OWNER:  شرکت سست و سویی توستر ایرانیاان (سهایی نیاان)	BUSHEHR PETROCHEMICAL COMPANY MEG PLANT						EPC CONTRACTOR:  Chagalesh-Enerchimi-Steam Joint Venture BUPC-MEG PLANT PROJECT		
	MC :  شرکت سست و سویی توستر ایرانیاان (سهایی نیاان)	HAZOP / SIL REPORT							
		Project	Area	Phase	Unit	Dis.	Doc.	Seq.	Contract No : 52-98/445
Owner Document Number: 17811-78	BU	20	VD	303	QC	REP	0105	Rev.: 01	Page 1 of 48

HAZOP / SIL REPORT

**BUPC MEG Plant HAZOP & SIL Report –
N2 and Air Compressor
Detailed Design**

Client Report No: BUPC-17811-OO-0703

DRAWING TITLE: 17811-03 P&ID FOR INSTRUMENT AIR COMPRESSOR

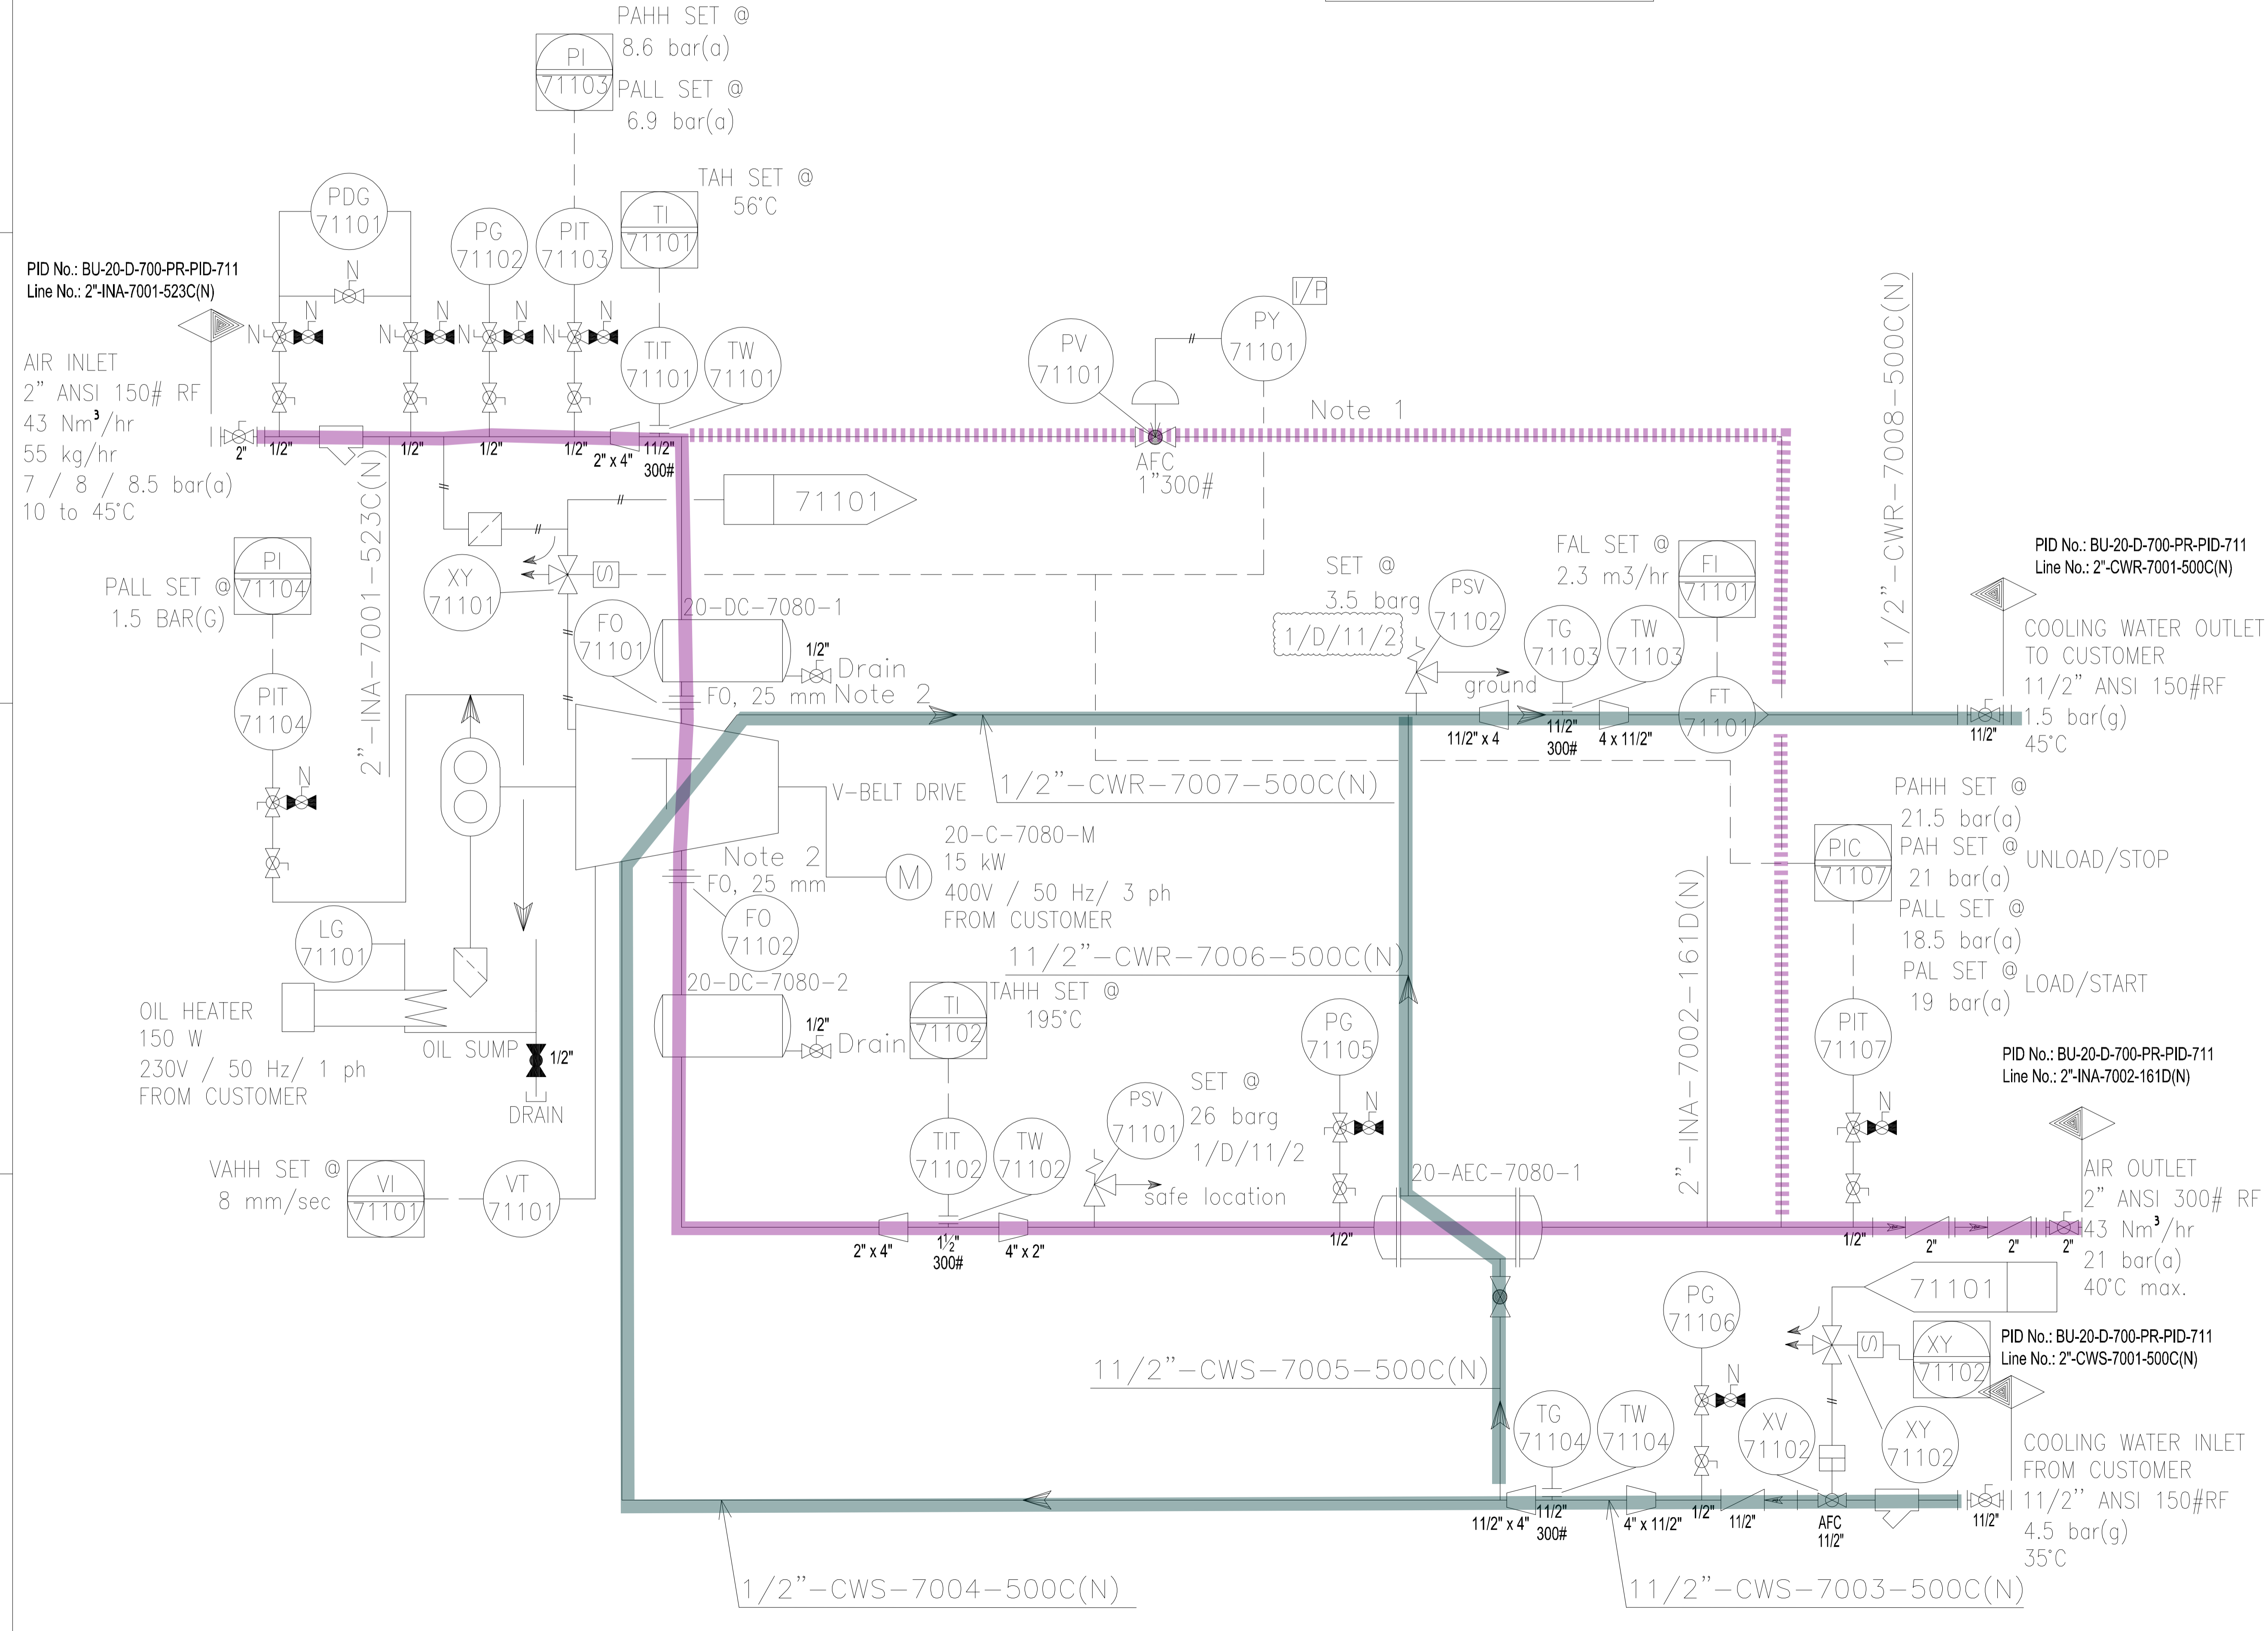
03.1.1.1	Flow	No / Not	No/Less Flow	No Air supply from Plant	1. No Supply to the compressor leading to underpressure at the suction side of the compressor. Worst case is if recycle line is closed. No vacuum is expected, however the discharge pressure will decrease. Increase of temperature of the first stage exceeding the design temperature of the Compressor. Less supply to the end users. Vibrations of the axis of the compressor is possible. No loss of containment. No hazardous consequence. Asset damage (L) < 5000 US\$.	L	1. PIT-71103-PALL to Trip 20-C-7080 (UCP ESD) 1. PIT-71107-PALL to Trip 20-C-7080 (UCP ESD) 3. TIT-71102-TAHH to trip 20-C-7080 (UCP ESD)	1	3	SIL 0	1. PIT-71103-PALL to Trip 20-C-7080 (UCP ESD) 1. PIT-71107-PALL to Trip 20-C-7080 (UCP ESD) 3. TIT-71102-TAHH to trip 20-C-7080 (UCP ESD)	3	No action

03.2.1.1	Flow	More	More/High Flow	More flow over the recycle line by 'Fail Opened AFC PV-71101 or control failure to opened valve in case AFC should be NOT fully opened.	1. Decreased pressure and temperature in the second stage of the compressor. Less supply to the plant/ end user. No hazardous consequence; No asset consequence.		1. PIT-71107-PALL to trip 20-C-7080 (UCP ESD)
